CITY OF CAMBRIDGE

BOARD OF ZONING APPEAL

BZA Application Form

LOCATION OF PROPERTY: 27 Fayerweather St., Cambridge, MA

EXISTING GARDEN WITH PROPOSED CARRIAGE HOUSE + CURRENT GARAGE (OVERLAY)

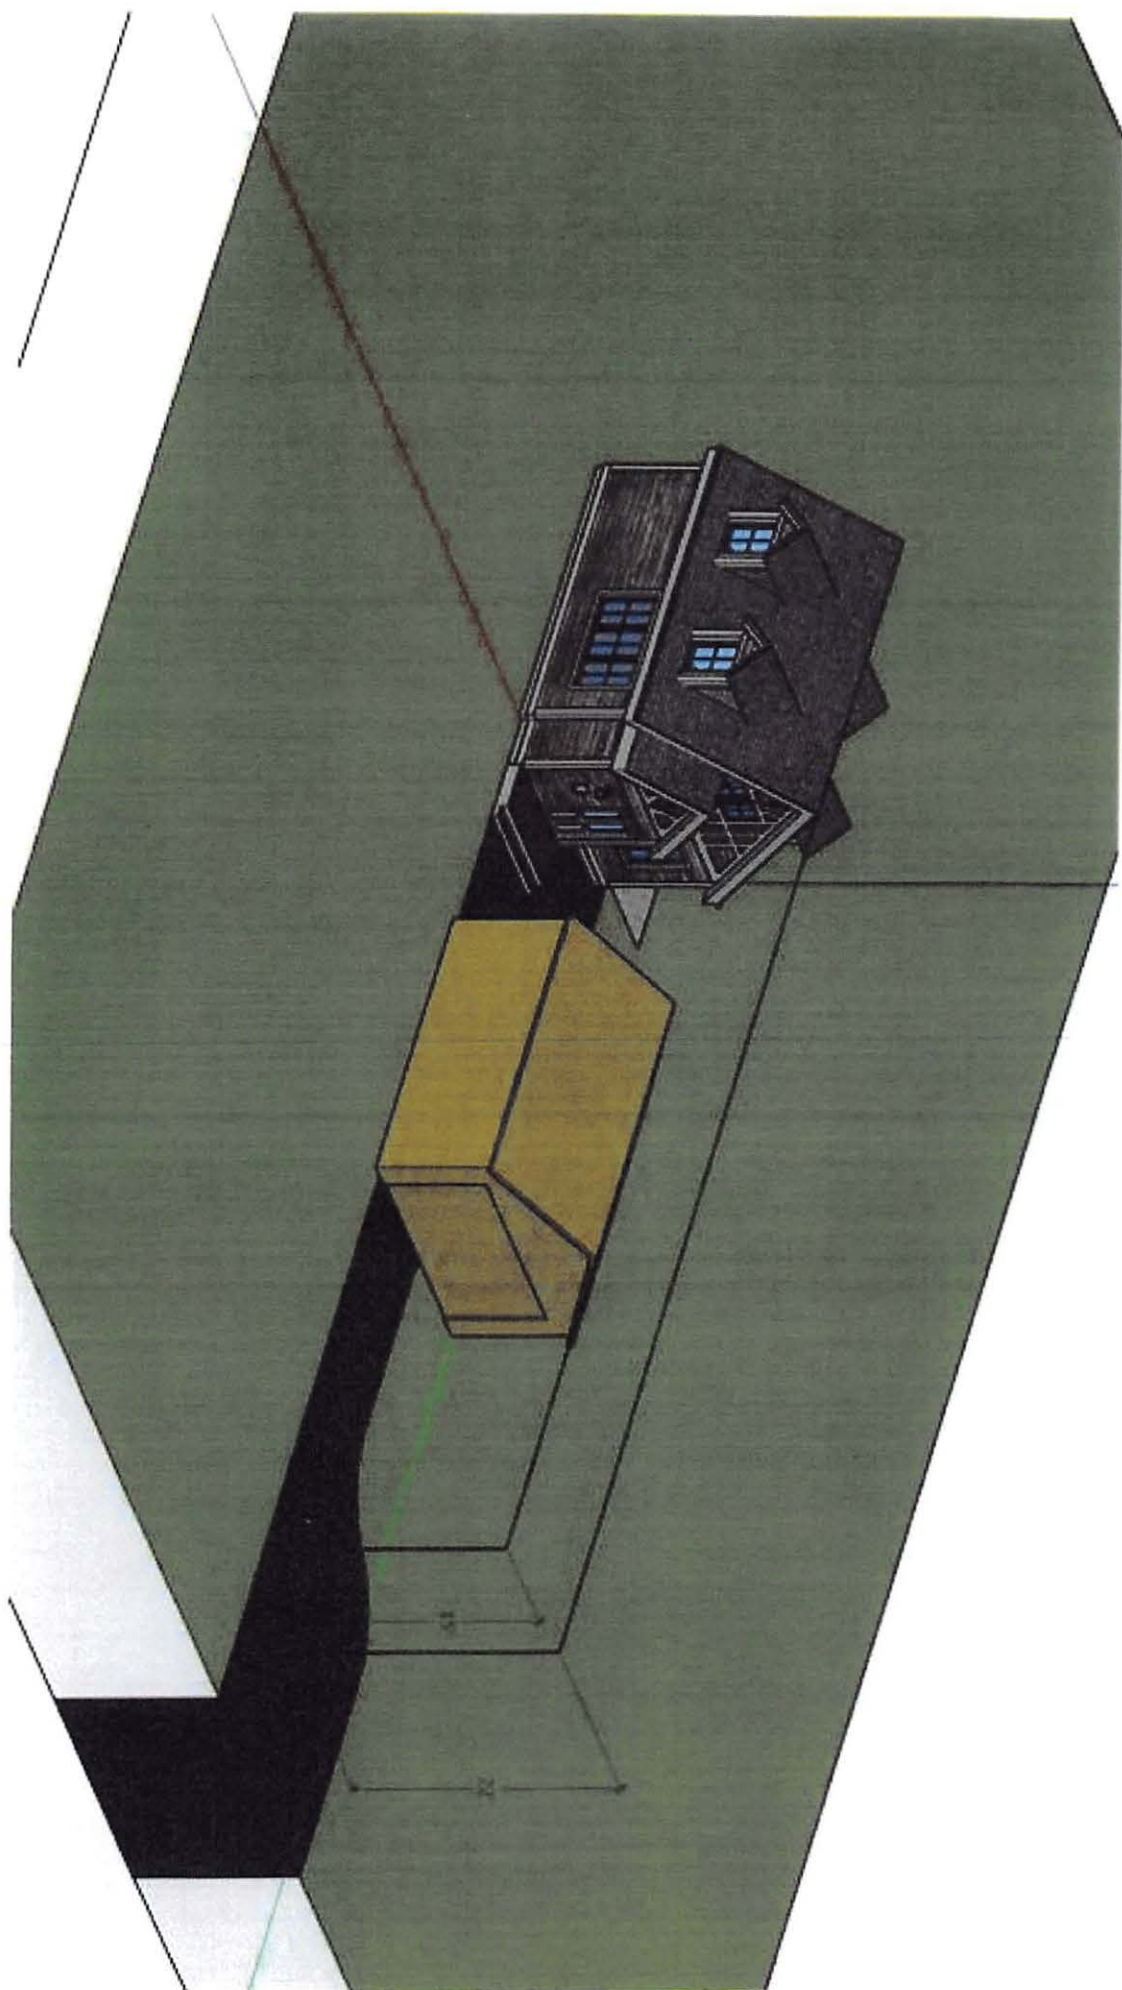
The four panel comparison study that has been prepared by our architect Greg Dennee and submitted to the Board clearly demonstrates the negative impact on our use of our patio and garden. To further illustrate for the Board the adverse effect of raising the height of both the front and rear garages, we engaged the services of our contractor, Kistler and Knapp Builders, Inc. to install four twenty-two foot high poles along the property line. Submitted herewith is a photo of the rear yard patio and garden that depicts the two rear poles placed along the boundary line facing the rear garage, showing the open space that the roof of the proposed accessory building would be filling in. Also submitted herewith are a photo looking from the rear patio toward the two front poles that were placed next on the side of our house facing the front garage, and a photo from the second floor window looking over the existing front garage with the same two front poles in place.

Excerpt from Sheet A2-1 EX

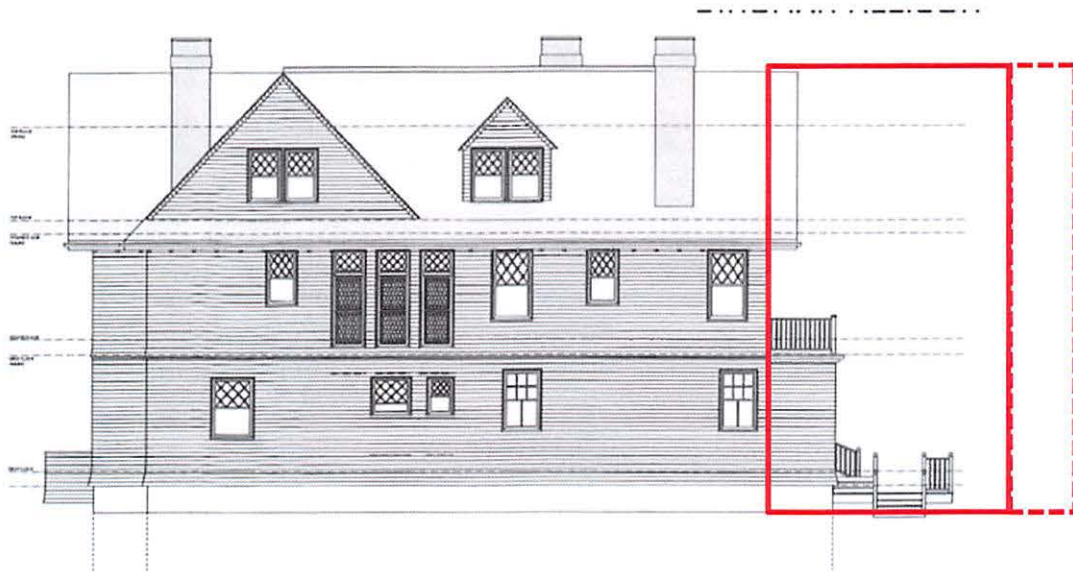
² Note that the submitted plans appear to mislabel the left and right sides as the front and rear elevations, respectively, and vice versa.

The overall effect on light, air, and privacy for 31 Fayerweather Street — from the introduction of what is effectively a new 20-foot-by-39-foot structure, ten feet closer to its lot line than allowed under the Ordinance — will by any measure be substantially more detrimental than the existing nonconforming structure under G.L. c. 40A, § 6 and Section 8.22.2(d) of the Ordinance.
